Access Compliance Report

Intersection ID: 43289	Main Street: ALEXA_RD	Cross Street: BERKELEY_POND_DR	Location: SW
ADA ID: AD36E39DA91B	Ramp Type: PerpDiag	Initial Pass/Fail: Fail	Overall Compliance: No
Severity Score: 33.75			
Codes/Mitigation Info/Possible Solution		Field Measurements/Component Compliance

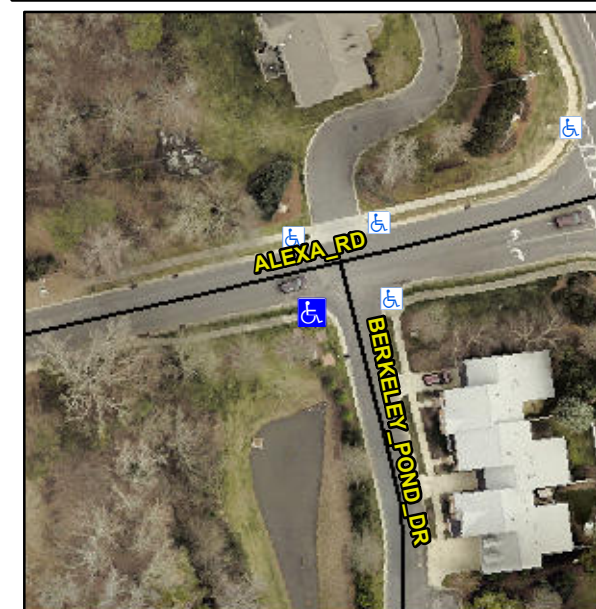
Not Found, R304.5.1, R304.5.3

Compliance	Description	Data	Compliance	Description	Data
N/A	Ramp Length (in)	52.0	Yes	Ramp Slope (%)	5.6
No	Ramp Width (in)	45.0	No	Ramp XSlope (%)	10.6
N/A	Flare Type LT	N/A	N/A	Flare Type RT	N/A
N/A	Flare Slope LT (%)	N/A	N/A	Flare Slope RT (%)	N/A
N/A	Flare Traversable LT?	N/A	N/A	Flare Traversable RT?	N/A
N/A	Landing Length (in)	N/A	N/A	DWS Provided?	N/A
N/A	Landing Width (in)	N/A	N/A	DWS Contrast?	N/A
N/A	Landing Slope (%)	N/A	N/A	DWS Length (in)	N/A
N/A	Landing X Slope (%)	N/A	N/A	DWS Full Width?	N/A
N/A	Landing Curb? (Y/N)	N/A	N/A	DWS Offset (in)	N/A
N/A	Shared Landing?	N/A			
N/A	Gutter Ponding?	N/A	N/A	Gutter Slope (%)	N/A
N/A	Gutter Lip Ht (in)	N/A	N/A	Gutter X Slope (%)	N/A
N/A	Painted X Walk1?	No	N/A	Painted X Walk2?	No
	X Walk 1 Direction	To E		X Walk 2 Direction	To N
N/A	X Walk 1 Width (in)	N/A	N/A	X Walk 2 Width (in)	N/A
	X Walk 1 Slope (%)	1.1		X Walk 2 Slope (%)	0.6
	X Walk 1 X Slope (%)	13.1		X Walk 2 X Slope (%)	6.1

Remove & Replace Curb Ramp With Two New Directional Ramps or Equivalent.
